# UNITED STATES PATENT AND TRADEMARK OFFICE

APPLICATION NO.	FILING DATE	FIRST NAMED INVENTOR	ATTORNEY DOCKET NO.	CONFIRMATION NO.
10/002,574	11/14/2001	David E. Branson	10003836-1	4285
7590 HEWLETT-PACKARD COMPANY Intellectual Property Administration P.O. Box 272400 Fort Collins, CO 80527-2400			EXAMINER LOVELL, LEAH S	
			ART UNIT 2885	PAPER NUMBER
			MAIL DATE 11/16/2007	DELIVERY MODE PAPER

<b>Office Action Summary</b>	Application No.	Applicant(s)
	10/002,574	BRANSON ET AL.
	Examiner	Art Unit
	Leah S. Lovell	2885

## **DETAILED ACTION**

**FIGURE A: Taken from figure 2 of Haenen and modified to illustrate the window [10] accounting for 30% and 70% of the total area of both the reflector [11] and window [10].**

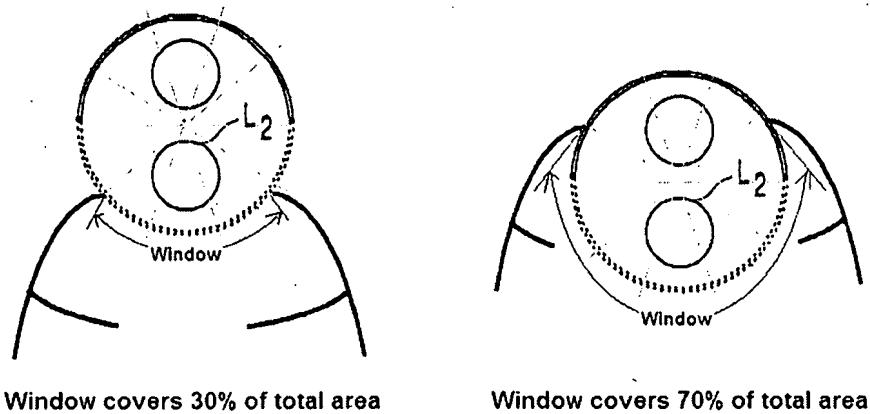
wherein the first and second reflectors [3] form a sharp corner at a junction with the interior reflective surface of the body [column 4, lines 58-60 suggests that the first and second reflectors 3 are positioned such that the window 10, as defined by the reference, accounts for 10 to 70% of the total area of the window and housing; if positioned such that the window is accounting for 10-30% of the total area, a sharp corner will result between the reflector/interior reflective surface 11 and the first and second reflectors; see figure A provided below].
